RE: Principal: NATCO, Inc.
Obligee: St. Tammany Parish Department of Finance
Bond No.: 087-SB-104998055
Project: Administrative Complex (Towers Building)
Renovations

ATTACHMENT B

PCO #61 – Fire Stair Handrail Corrections

Landmark Reference 3

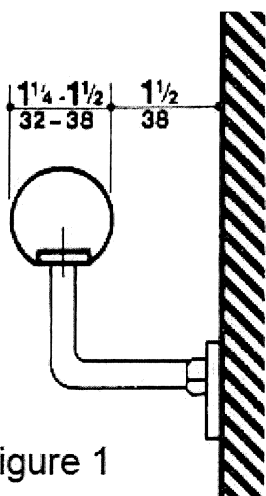
Drawing H-1; Article 4.9 Stairs; Clause 4.9.4 Handrails; Item No. (3) is shown below. This clause details the requirements for the clear dimensions between the wall and the handrail to be 1½". See item (3) below.

The sketch below shows in graphic form what is specified within the Contract Documents.

Landmark Reference 4

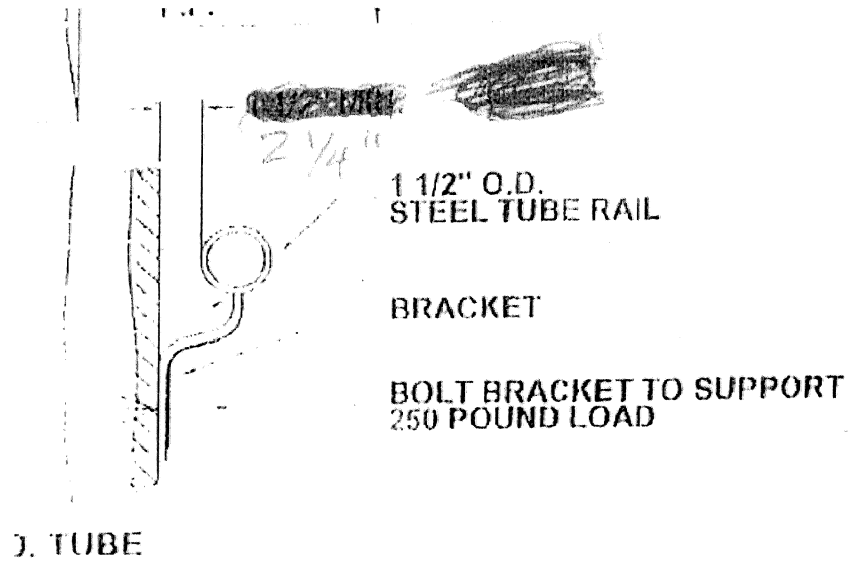
Parish representatives have indicated that this issue was identified by the Fire Marshal at the time of their initial review and prior to the start of construction. The Parish claims that this inspection report was incorporated into the Takeover Agreement. To the best of our knowledge, the Contract Documents were not amended or modified to address this issue nor was this report incorporated into the Takeover Agreement.

The local fire marshal brought this issue to our attention on November 15, 2010. Following the inspection, Dammon provided a marked up document, shown below (*Landmark Reference 4*), which calls out the requirement of $2 \frac{1}{4}$ clear between the wall and the handrail. The handrails and guardrails were already installed at this point and required field modifications to comply with the new design criteria.

Landmark Reference 6

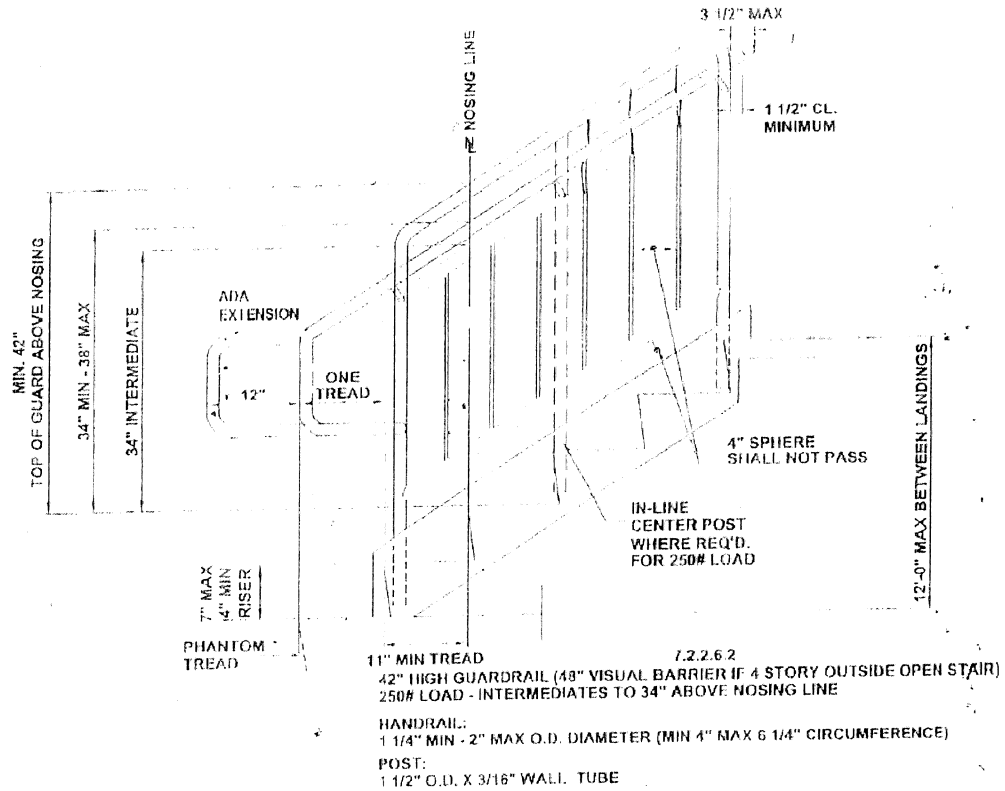
In the Fire Marshall's inspection report he indicated that the handrails which had been installed at approximately 32" height above the stair tread were not acceptable and needed to be repaired. Please refer to the inspection report which has been attached or item 7.2.2.4.4.1 which was copied from that document shown below.

New handrails on stairs shall be not less than 34 in. (865 mm), and not more than 38 in. (965 mm), above the surface of the tread, measured vertically to the top of the rail from the leading edge of the tread.

Landmarks Reference 8

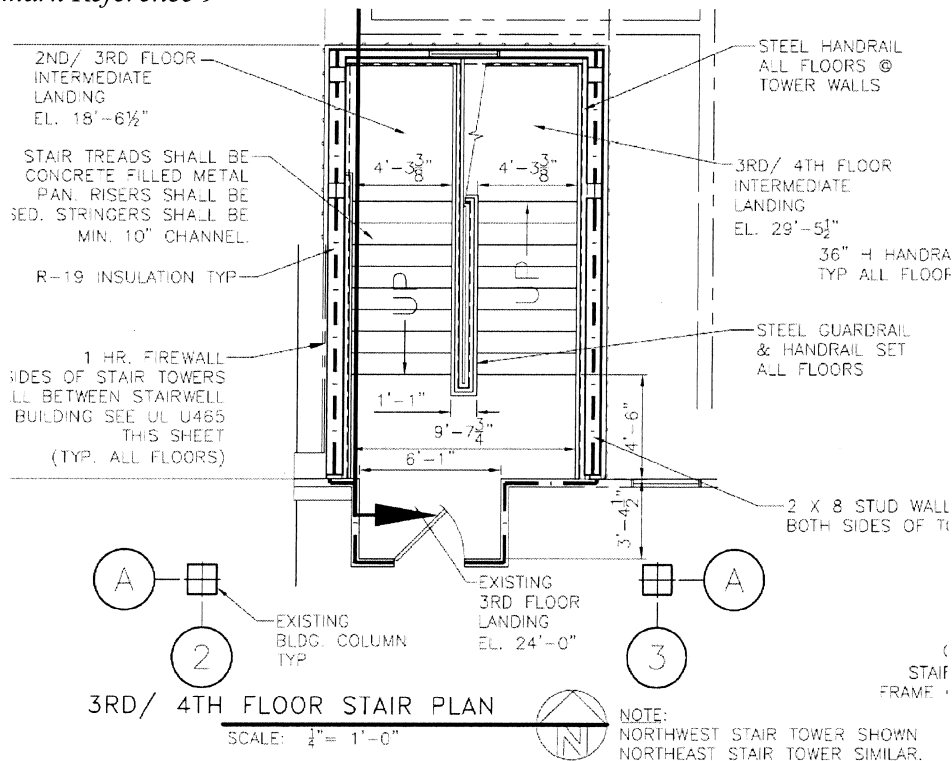
Drawing H-1; Article 4.9.4 Handrails; Details the installation requirements for both continuous and non-continuous handrails. See (*Landmark Reference 8*) below.

The article above gives the contractor the option of providing a continuous handrail or a discontinuous handrail. In the design details it is not clear what option (continuous or discontinuous) the designer chose.

Landmark Reference 9

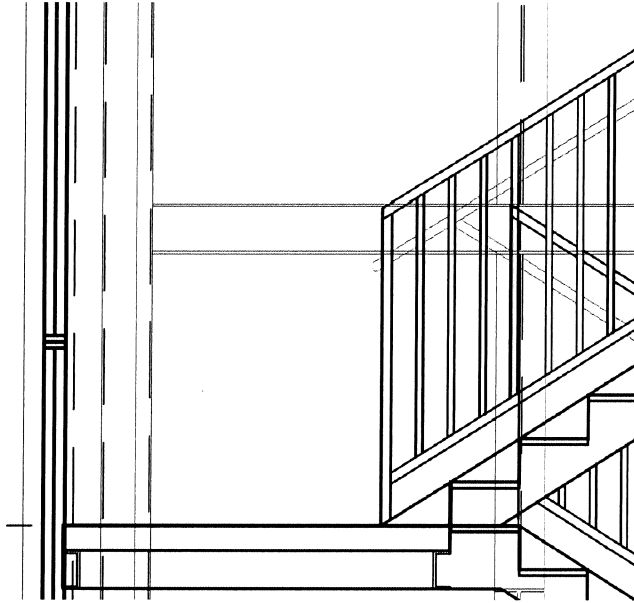
On sheet A.18 detail Sheet A.18, 3rd/4th Floor Plan shows the handrail to be continuous.

On the same sheet see Typical Section of Stair tower Sheet A.18, Detail SA/A18/A18 it shows a discontinuous handrail which is turned into the wall. *Landmarks Reference 10*

Reference 1

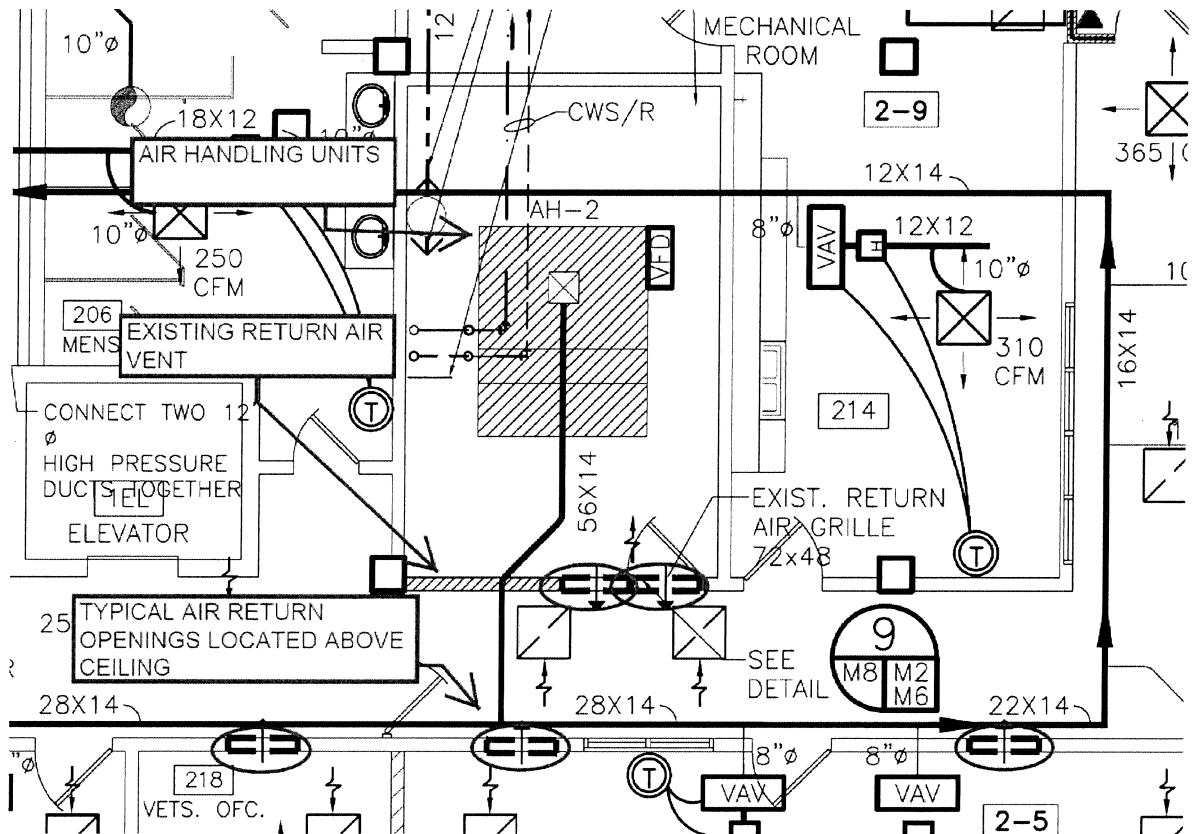
During the course of construction the City Mechanical Inspector questioned there being sufficient return air flow to allow for proper operation of the mechanical system. This issue was investigated by a registered engineer employed by Star Services and later determined to be a problem. Based on Star Services design calculations, it was determined that approximately 41 additional (200 Sq. Inch) openings were needed beyond that which is shown on the Takeover drawings.

The estimated cost to remedy the problem was initially discussed with the Design team and the Owner before a PCO was created. The initial response from the Owner suggested that the return air deficiency identified by the City Mechanical Inspector would not be an issue if NATCO had reinstalled the existing return air vents (one at each mechanical room) that were shown on the drawings to remain. This vent is labeled, "EXISTING RETURN AIR VENT" on Reference one, see page 1.

The existing grill referred to above was a 72" x 48" return air vent located in the south wall of Mechanical Room on floors two through six. Per the contract, these vents were scheduled to remain. However, it became necessary to remove the entire south wall of the mechanical room (along with the vents) to install the AHU on each floor. At the time of Landmark's arrival on site, the AHU's were in place and south wall of the mechanical room had been reconstructed. The existing vents were not reinstalled during this process.

It is our understanding that the re-installation of the vents would have violated code based on the intended design of the new mechanical system. Per the City Mechanical Inspector, the design must provide for smoke separation between the air plenum and the corridor. The vent, if re-installed, would eliminate this separation and was not acceptable to the City of Slidell.

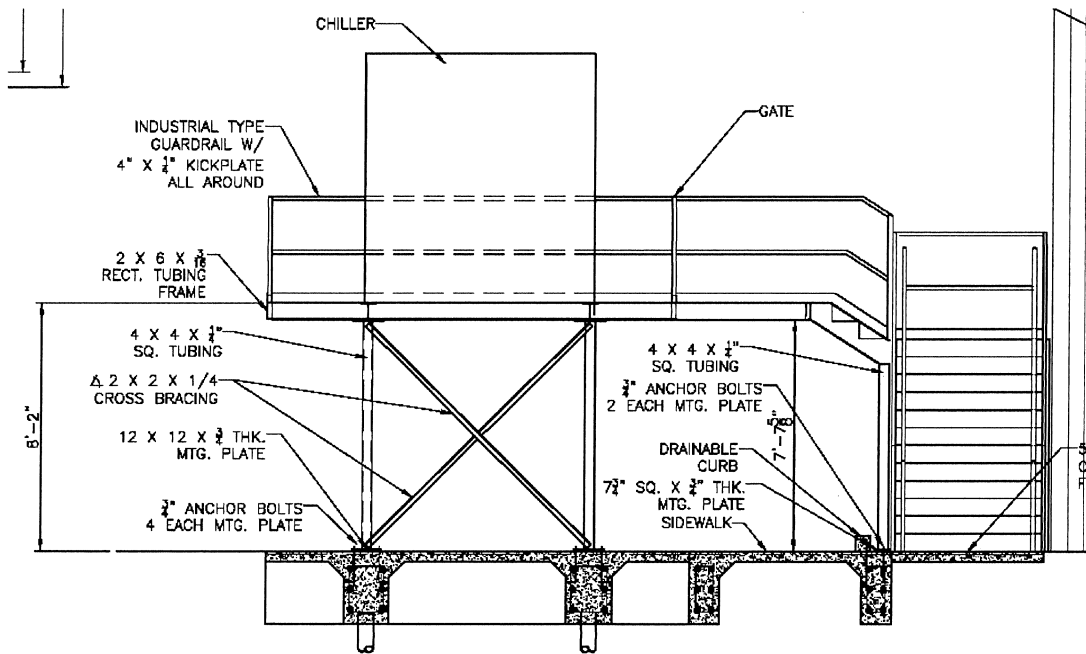
Both the guardrails and the gate were constructed in accordance with the design details included within the Takeover Drawings. The design of both the guardrail and the rails along each side of the steps were shown on the drawings. The gate was not shown on the contract documents and its design was coordinated with the Fire Marshall.

The Fire Marshall rejected the construction of the guardrails and gate on the grounds that their design did not meet Life Safety requirements.

The large scale detail SF/S2/S6 located on sheet S-9 shows the design of both the guardrail on the landing and the rails along the south side of the steps leading up to the gate. Note the guardrail design matches that of the Chiller platform. The design shown here is identical to that constructed, which was rejected by the Fire Marshall.

Landmark Reference 2

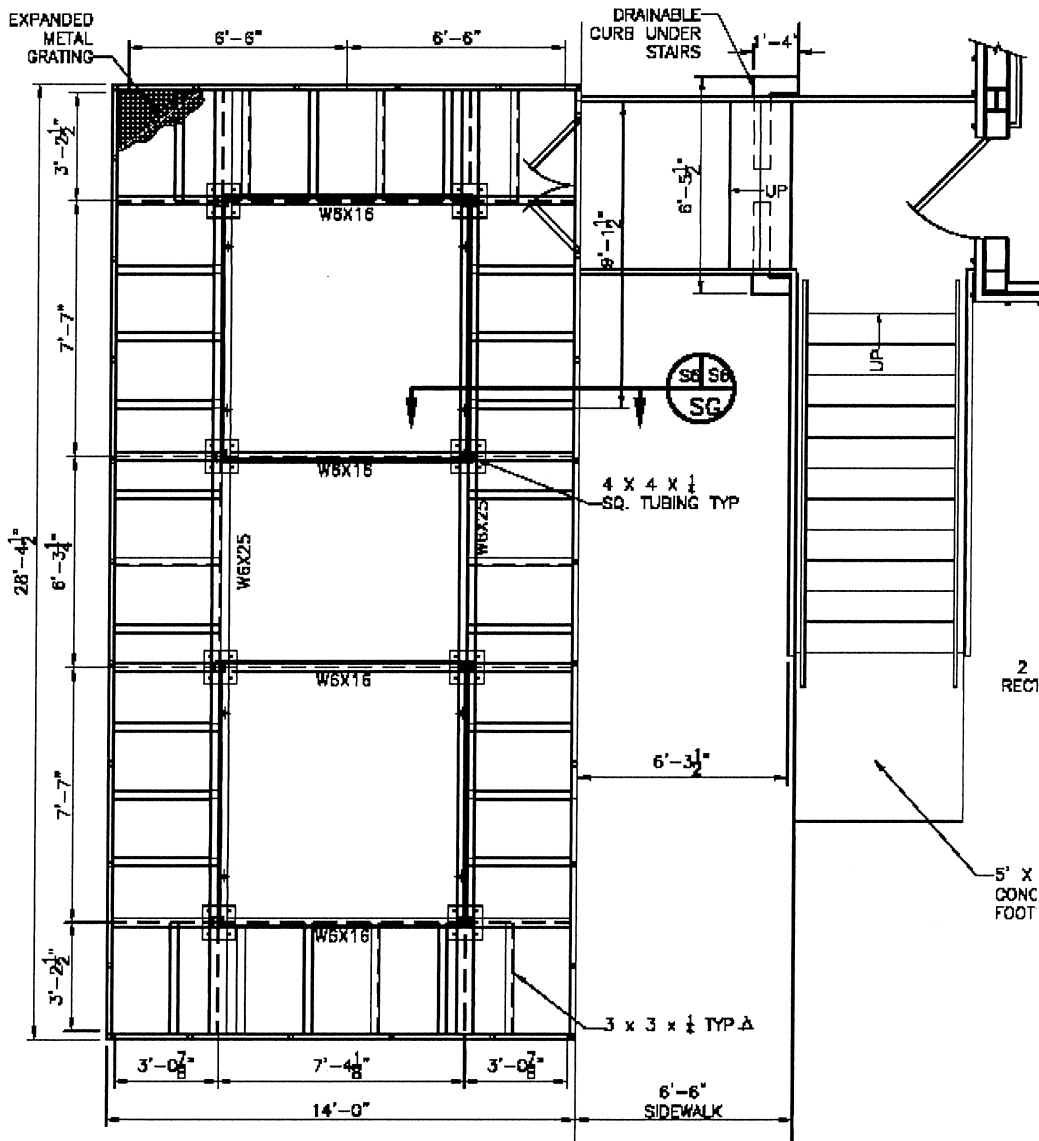
The gate location is shown in the detail above, however there is no information shown on the drawings anywhere that would indicate that it was to be designed any differently than the rest of the guardrails that run along the entire perimeter of the chiller platform. The only other information provided that would describe the gate is the chiller plan that is shown below.

7.2 Cooling tower Means of Egress Components.
Still need to provide intermediate spindles or other means of protection for outside gates on landing leading to cooling towers.

Landmark Reference 1 – Existing condition in error.

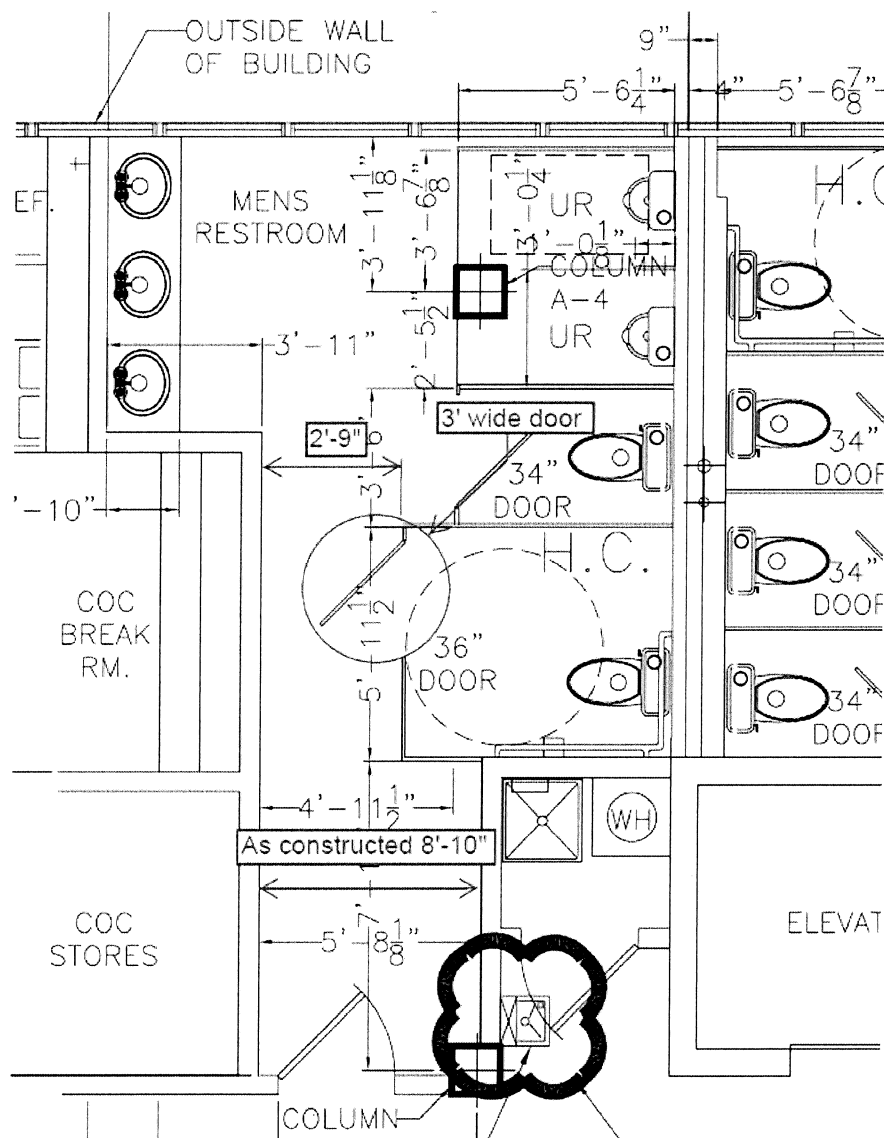
- The following detail was taken from sheet A.21 (Detail 6/A5/A2.1). Based on the design drawings, the handicapped stall door would not open all the way with design dimensions. The aisle way between the handicapped stall and the west wall would have been approximately 2'-9" wide. The aisle widths in the other bathrooms typically are about 5'-8". The as-built dimension at this location is 8'-10", providing approximately 3'-2" more clearance than is shown on the design drawing. The adjustment of this walls location provides for functionality within the restroom and supports the need to shift the disputed walls to the west of their design location.

Landmark Reference 2 – Toilet room not useable.

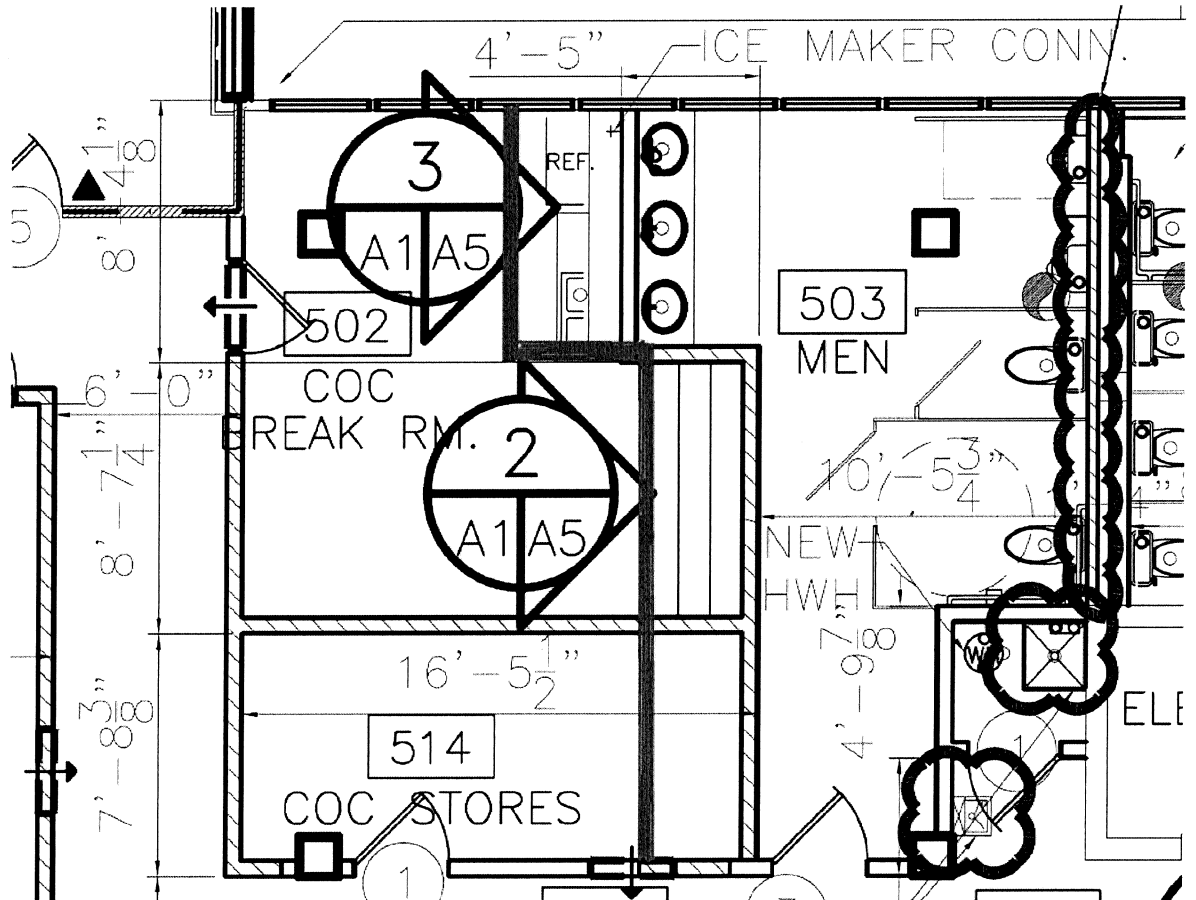
See below the actual location of the common wall between the Toilet Room 503 and Rooms 502 and 514.

Landmark Reference 3 – Red line shows the location of where the wall was actually located. Note the how it infringes on the space that was to be provided for these three rooms.
